An Environmental Impact Statement (EIS) was prepared on behalf of the proponent, Macquarie Corporate Holdings Pty Ltd (Macquarie), in support of a detailed 'Stage 2' State Significant Development Application (SSD DA) (18_9326) for the construction and operation of Over Station Development¹ (OSD) located above and integrated with the southern entry of the Sydney Metro Martin Place Station. The EIS and accompanying documents were placed on public exhibition from 11 October to 7 November 2018.

2.0 Key issues and proponent's response

Figure 7 Relationship between the South Site podium and 50 Martin Place

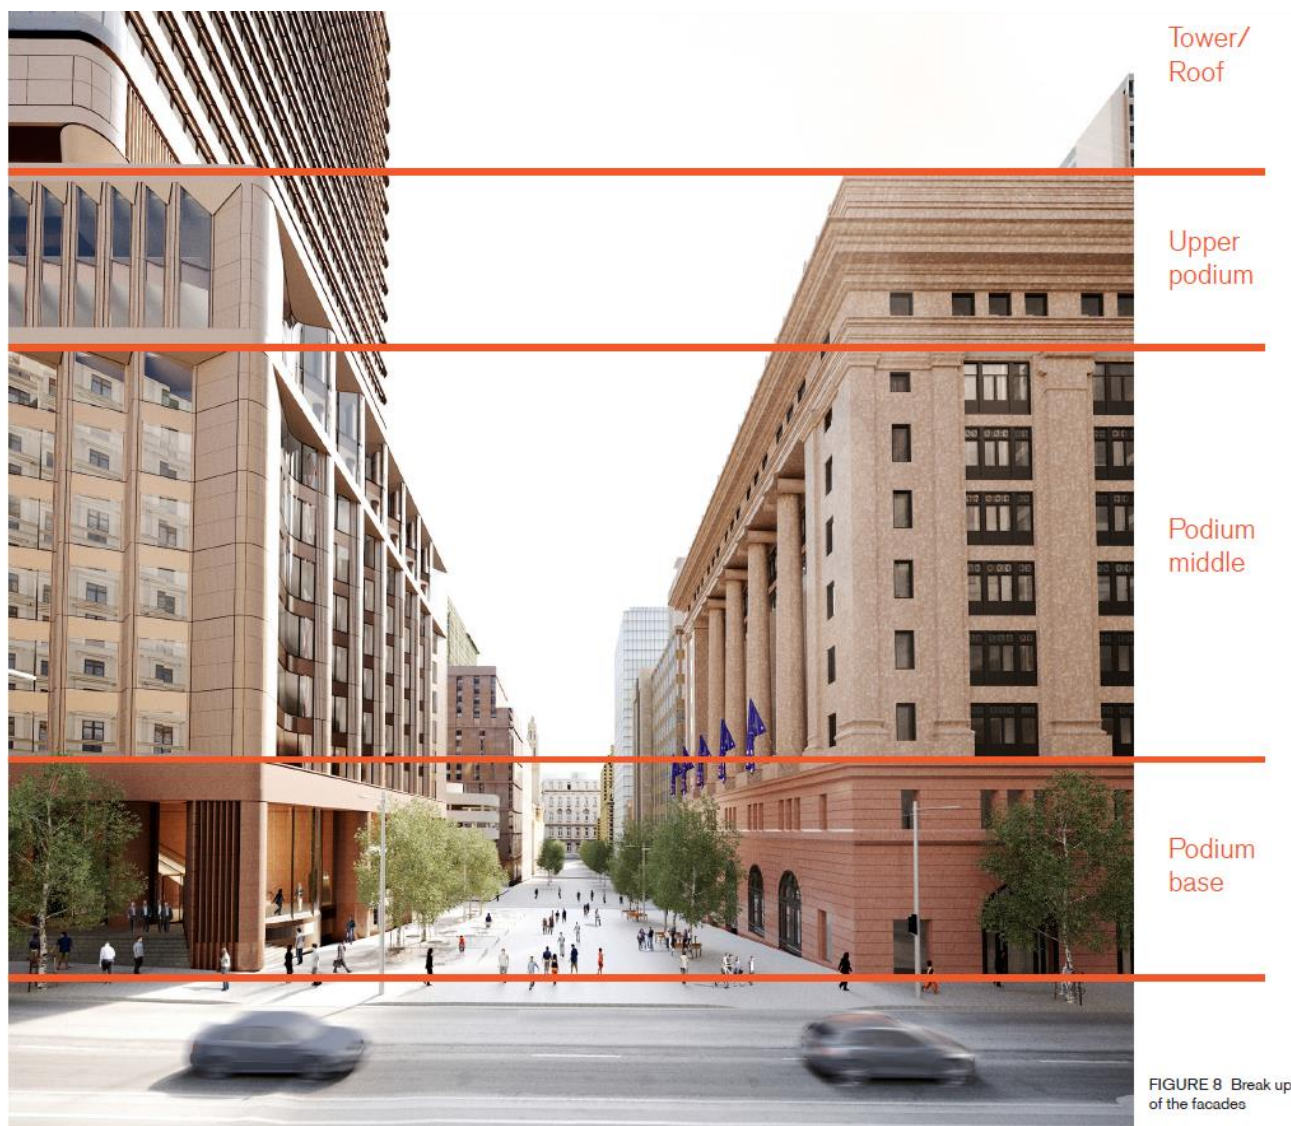
The Department requested further justification and illustrations be provided to detail how the proposal reinforces the street frontage conditions along Elizabeth Street and Castlereagh Street and how the proposal integrates with the lower scale of 50 Martin Place.

- **Podium base:** The scale, materiality and monumental architectural language of the proposal's podium base directly relates to stone base of 50 Martin Place. These are the most publicly active levels containing metro station entries, retail and commercial lobbies. The stone cladding and distinct architecture differentiates these public zones, and frames the building's entries (refer to **Figure 7** below).

- **Upper podium:** The upper podium of the proposal is bisected by strong horizontal bands that break up the podium massing and reflects the corresponding 'entablature'⁴ of the 50 Martin Place building. This feature will be read along both Elizabeth Street and Castlereagh Street, and is continued in the detailing on the southern façade of the proposal, reinforcing and respecting this significant element of the character of both streets immediately below the street frontage height set by the 50 Martin Place parapet (refer to **Figure 7** below).

Figure 20 Proposed southern elevation of the building, as viewed from Elizabeth Street

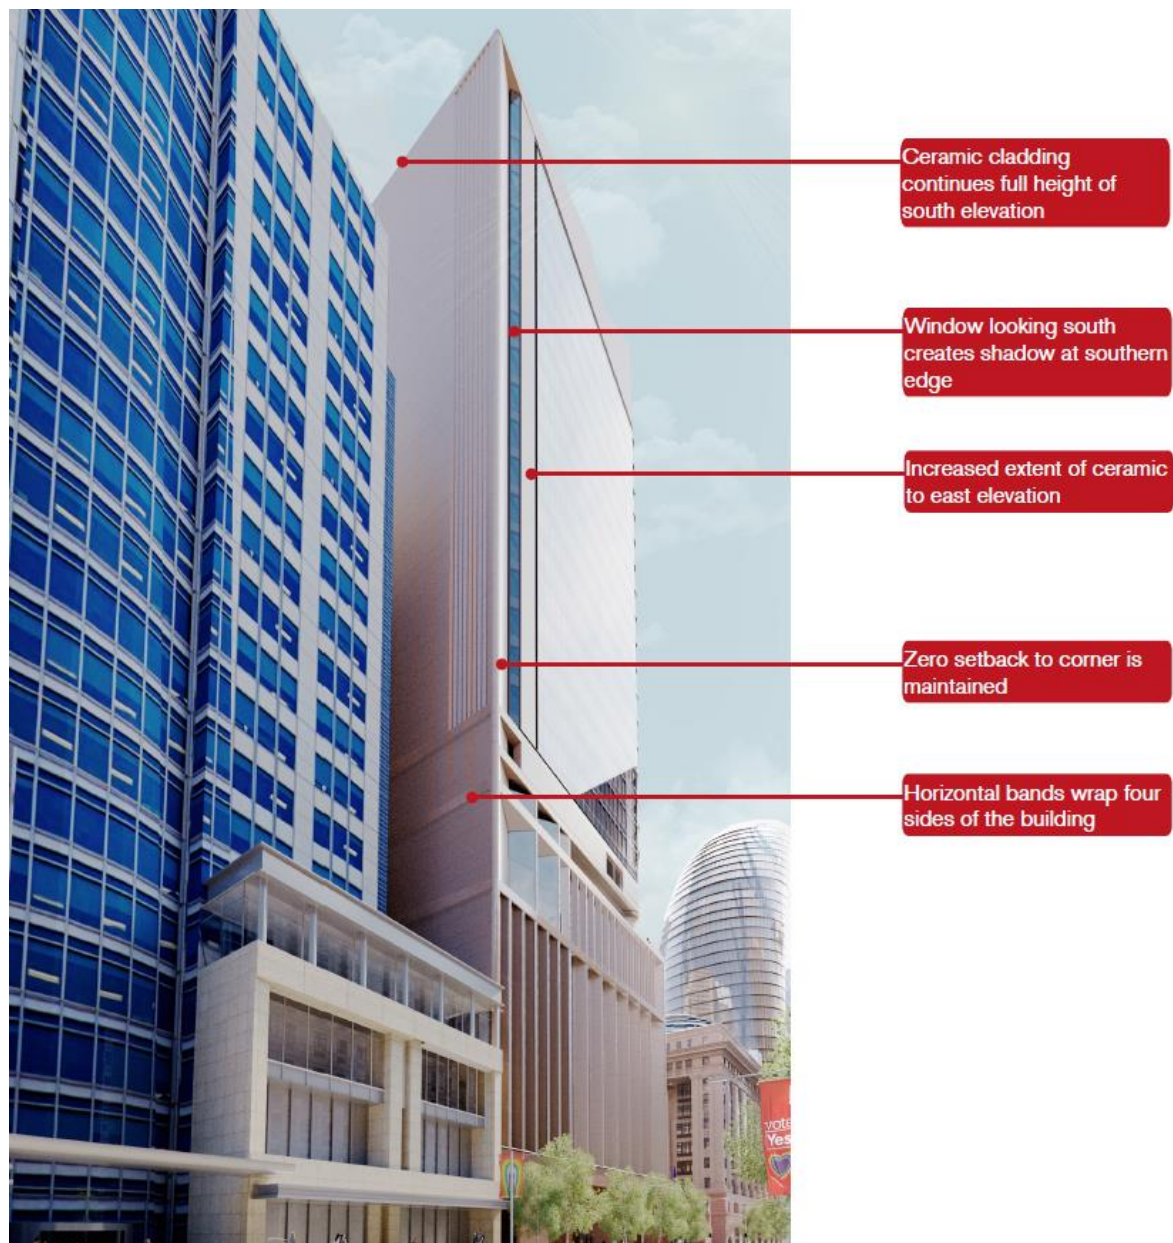
The detailed design of the southern elevation of the South Site has been a significant focus of the DRP, and has been revised through consultation with the DRP and in response to the Department's comments through DRP #7, #8 and #9. Feedback from the DRP centred on the need to articulate the wall, particularly at the south-east and south-west corners. The DRP noted that this would mitigate the appearance of a continuous street wall, which would likely occur if future development to the south had no setbacks above the podium.

The detailed design refinements described above to the southern facade, roof and southern corners ensure the South Site remains a legible feature in the streetscape in the event that future adjoining development does not adopt setbacks. This includes using ceramic folds on the eastern and western corners of the facade that appear to wrap the corners of the building, and incorporating a line of curved windows adjacent to the southern edge of the tower that create an indent and strong shadow line in the facade (refer to **Figure 20** and **Figure 21** below). This feature will articulate the separation between buildings and negate the risk of a continuous street wall should future development at 60 Castlereagh Street not adopt tower setbacks.

The proposed amendment to the design of the southern elevation is shown in **Figure 20**, and is discussed in **Section 3.0** of this report in more detail.

Figure 22 Elizabeth Street elevation illustrating the impact of 8m x 8m recesses defining the podium height

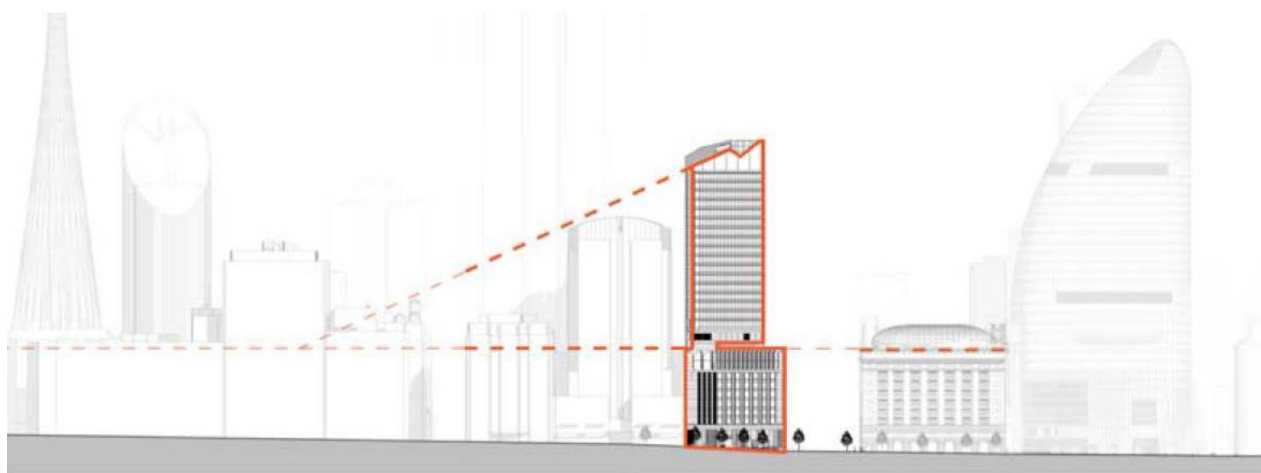
The Department notes that Council's recommendation to introduce 8 x 8 building returns at the southern corners of the envelope was previously considered by the site-specific OSD Design Review Panel (DRP) but was not supported. (Minutes of DRP Session 6 - held on 7 August 2018). The Department also considers the introduction of building returns will not provide an acceptable transition of built forms to the adjoining development to the south, which has a substantially lower podium height and tower setback of 5 m and 5.5 m to the street frontages.

In particular, it was identified that the redevelopment potential of sites to the south would be substantially limited if they were required to conform to the podium and street frontage height datum suggested by Council as well as the Hyde Park SAP, resulting in short, squat building envelopes; an arguably undesirable urban design and planning outcome for Elizabeth Street as an edge condition to Hyde Park. Defining the podium height could also have a potentially limiting effect on the flexibility of sites to the south to respond to the proportional relationship between the podium and the tower (as the height of the tower above the podium would be significantly reduced). This potential impact is shown in **Figure 22** below.

Figure 23 Through-site link looking east to Elizabeth Street from Castlereagh Street

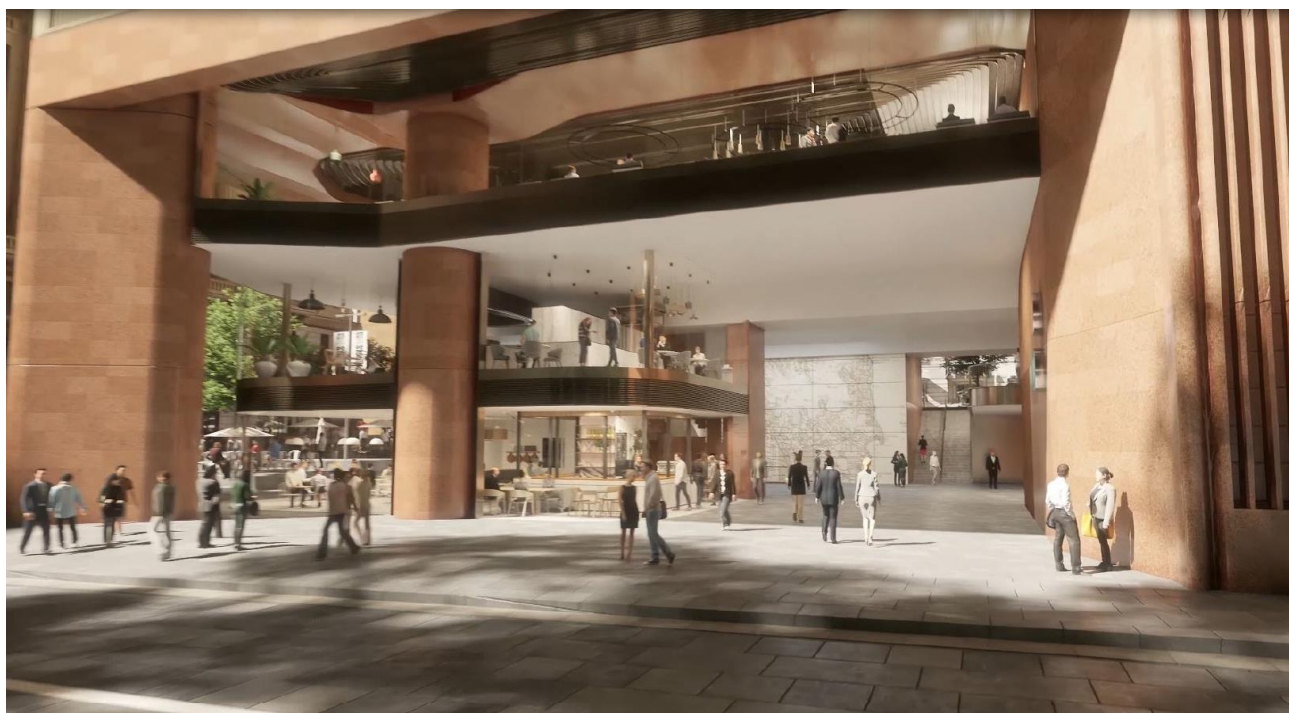
The Department has requested that the proponent prepare and submit a wayfinding strategy for the over station development in response to advice issued by the DRP and GANSW. The strategy shall be complementary to any wayfinding strategy and station design precinct plan for the metro station and shall include:

The detailed design of the through-site link has been tested and developed in consultation with the DRP, including the dimensions, alignment, and entrances to the link. Illustrations of the through-site link are provided in **Figure 23** and **Figure 24** below.

Figure 31 Proportion of the Elizabeth Street frontage used for services

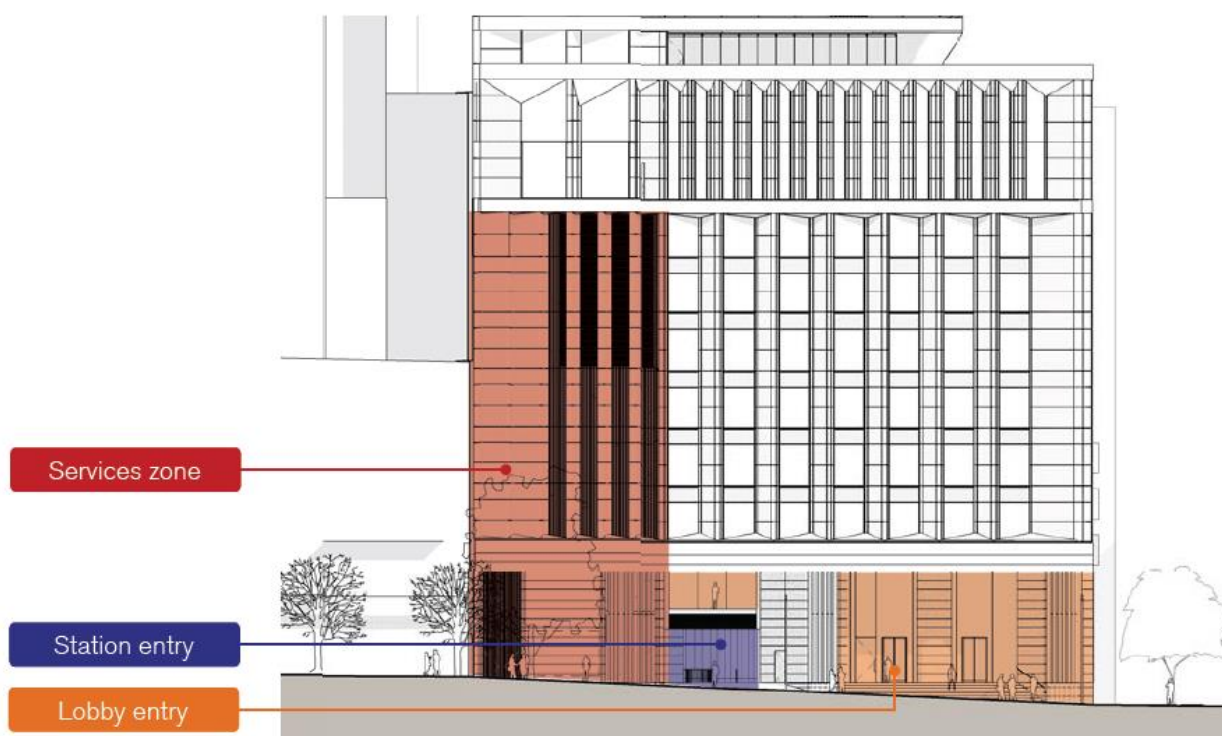
The City of Sydney has commented that the Elizabeth Street frontage of the building is compromised by services and the predominance of steps and ramps. The City has recommended that the floor levels be reviewed to provide grade entry from Elizabeth Street to station lifts and building lobbies.

The rationale for the design and location of services for the South Site has been to consolidate services to the core at the southern end of Castlereagh and Elizabeth Street, away from the primary active frontage to Martin Place and the station entrances. The proportion of the Castlereagh Street and Elizabeth Street frontages that are used for services in the overall facade have been minimised as much as possible, and the proportions are comparable between these frontages, meaning no one façade is overly burdened (see **Figure 31** and **Figure 32** below).

Figure 33 North elevation illustrative signage within proposed signage zone

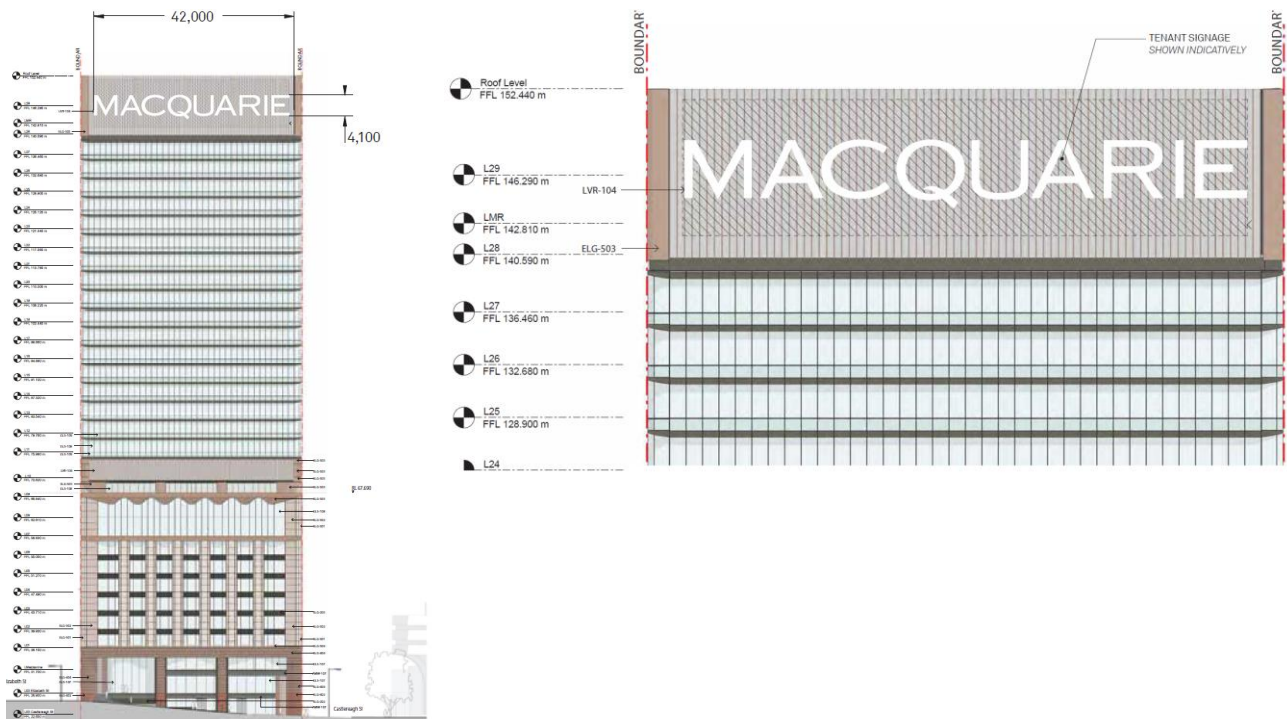
The Department requests that the proponent consider the appropriateness of the proposed signage zones, and the deferral of detailed design of the signs with respect to the proportion and size of proposed signage zones in response to the unique 'crown' roof line and form of the tower.

Included in **Appendix B** is a signage strategy which provides an illustrative scheme of potential future signage within the signage zones. The illustrative scheme demonstrates that signage within these zones can integrate with the curved façade of the building, in prominent locations and where they will not impact on tenant views. The zones are also located to ensure there is no impact to the operation of a future building maintenance unit (BMU). **Figure 33** illustrates how an illustrative signage design could integrate with the building within the north facade zone.
